Xcel Open House – Clean Energy Plan – Xcel Open House Kiowa Summary

Kindra Snow-McGregor, PE

Executive Summary

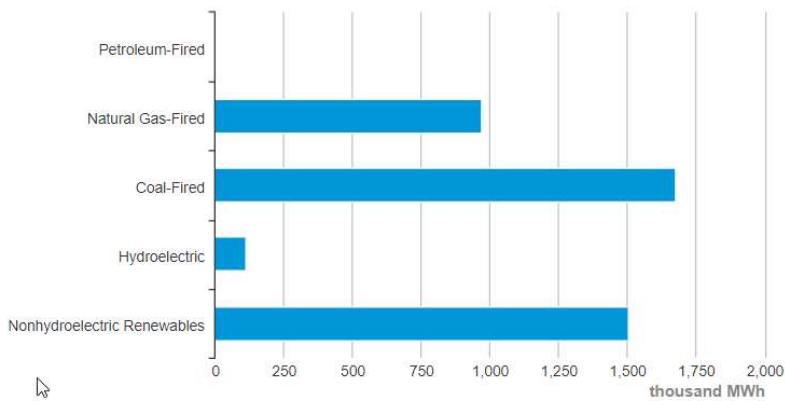
Note the plan is to add 3,900 MW of renewable energy into the grid by 2030.

To put the land use in perspective, let's assume that for that the land required for a wind turbine is 60 acres per MW⁵. **Based on their plan they will need to find roughly 138,000 acres to place wind farms on the eastern plains (215 square miles).**

For solar, if we assume 4000 acres are required for 300 MW generation (Atkima Solar Farm in Texas), that equates to 21,333 acres (33 square miles).

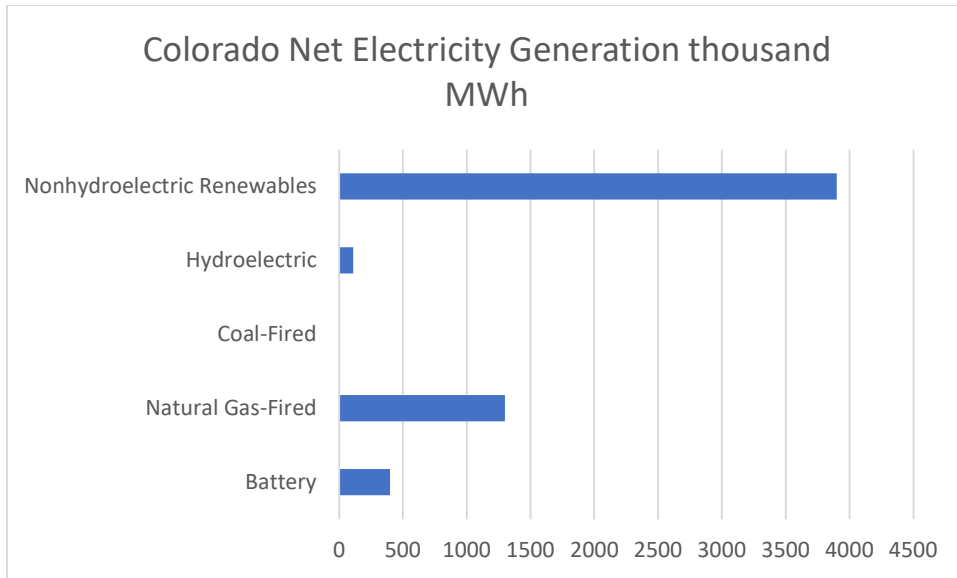
We all need to remember that the capacity factors (percentage of time the turbine or solar panel produces power) need to be considered to ensure reliable power generation. For example, the capacity factor of wind turbines range from 33 – 44% roughly. To have a reliable grid the wind generation needs to be backed up by 56 – 67 % of the time by another power generation source. Solar, best case is 25%. 75% of the time these installations are not generating power.

From their plans it is not clear if they are planning on the over-installation of wind and solar generators to account for the generators the capacity factors. But with that said, what has been proven is that even over installation of wind and solar in a location it is not insurance that the amount of power generation that is required will be provided from the generators.
